# A CULTURAL HERITAGE IMPACT STATEMENT

## 540 Manor Avenue, Rockcliffe Park

September 2020

Revised 2020-09-17

Figure 27: Landscape Plan. Source: James Lennox Landscape Architect.

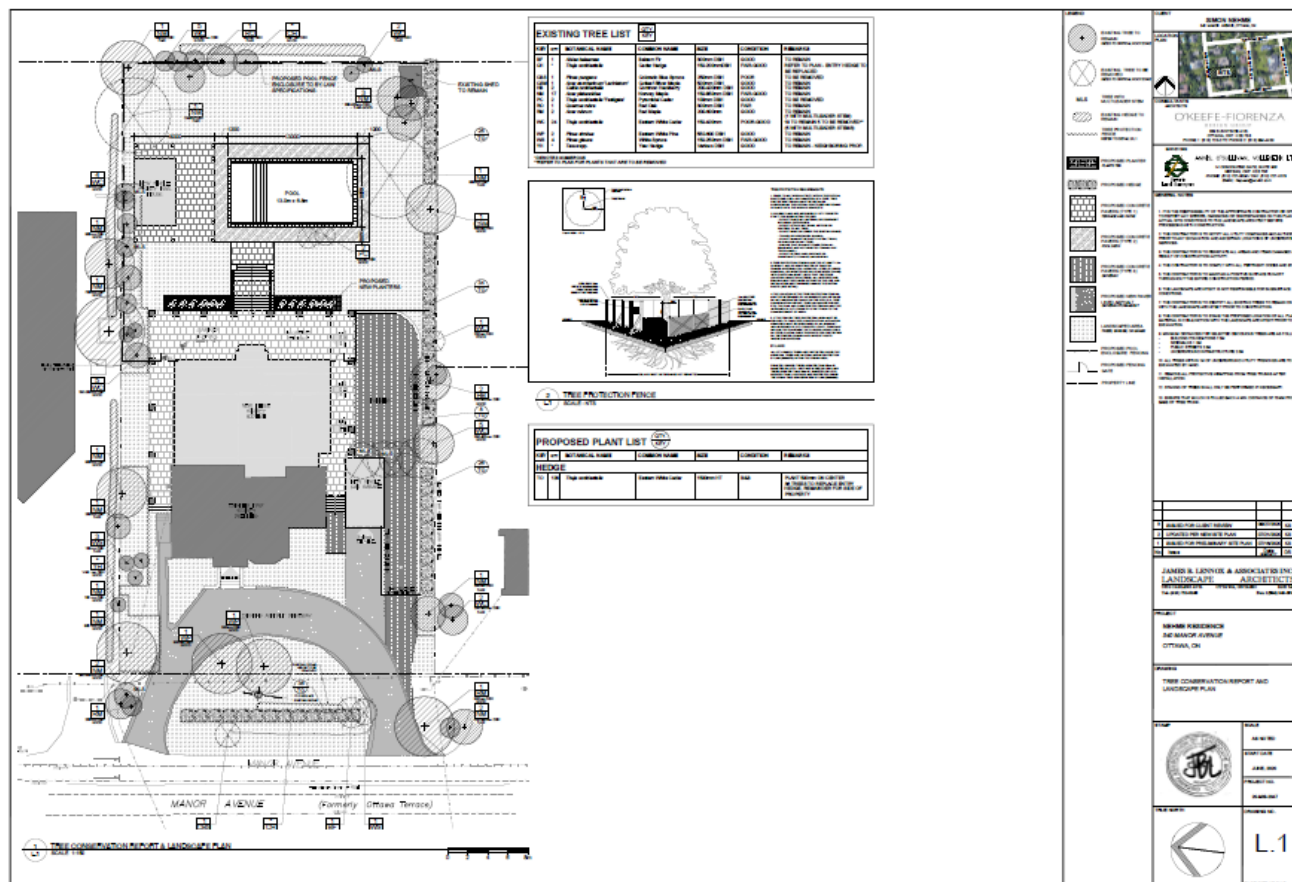
The removal of some of the hardscaping in the front yard is a positive change. Staff encourage you to explore further areas for improving the soft landscaping. When designing the landscape plan, please be sure to keep this in mind. A pool, pool deck and accessory structures all remove soft landscaping from the property. This will need to be balanced out with more softscaping whether it be grass, plantings or trees.

One option to decrease the hardscaping may be to consider permeable pavers on the driveway. Another alternative would

<p>be to remove the semi-circular driveway all together so that nearly the entirety of the front yard is soft landscaping.</p>
<p><i>Response: There is net reduction in the hard landscaping with the removal of the two existing garages in the front yard. The introduction of permeable pavers is positive and will be recommended to the landscape architect. The circular driveway is part of the picturesque landscape from the original design and serves an important part of the visual context. The mature White Pines and Cedar hedge control views from the street and focus views into the property almost like Kodak moments from either drive entrances. The introduction of an access driveway in the side yard to access the below grade parking garage will be coordinated with the neighbour to the south who is also planning a below grade parking area. The existing soft landscaping of the rear garden will be modified with the addition of a pool and extensive new plantings. The existing perennial gardens along the perimeter of the property are overgrown and will need to be redeveloped as part of the rear grounds landscape plan.</i></p>

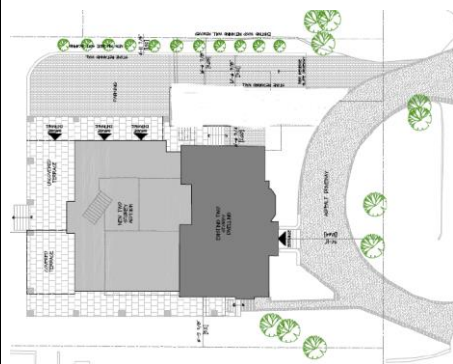
The removal of the front porch and vestibule is a positive element to the proposal, as it is not original. Please be reminded that any porch or canopy over the entrance should be in line with the Tudor style, and not seek to introduce a new style. John Stewart has provided some design suggestions.

<p><b>7.4 Additions and New Construction</b></p> <p><u>7.4.1 Alterations and Additions to Existing Buildings</u></p> <p><u>General Guidelines</u></p> <p>2. Additions to existing buildings should be of their own time and are not required to replicate an historic architectural style. If a property owner wishes to recreate an historic style, care should be taken to ensure that the proposed addition is an accurate interpretation.</p>	<p>Much of the design of the addition is inspired by classical elements, despite the house being of a Tudor Revival Style. While the Classical elements are not visible from the front, the design should take cues from Tudor Revival Style. Look for ways to soften the classical details. John Stewart has provided some suggestions for this. We are open to discussing this further if desired.</p>
<p><i>Response: The design of the new addition attempts to incorporate traditional design elements into the overall massing, roof lines and material finishes. The intent is to introduce a vocabulary that references traditional Tudor elements but executed with more contemporary materials.</i></p> <p><i>The architect has revised the rear elevation design to complement the Tudor style. As suggested, the curve of the arched doorways is flattened and a two storey Tudor style bay window introduced. A subtle arch in the canopy is introduced. The single columns have been retained.</i></p>

*Response: See the design of the entrance porch above*
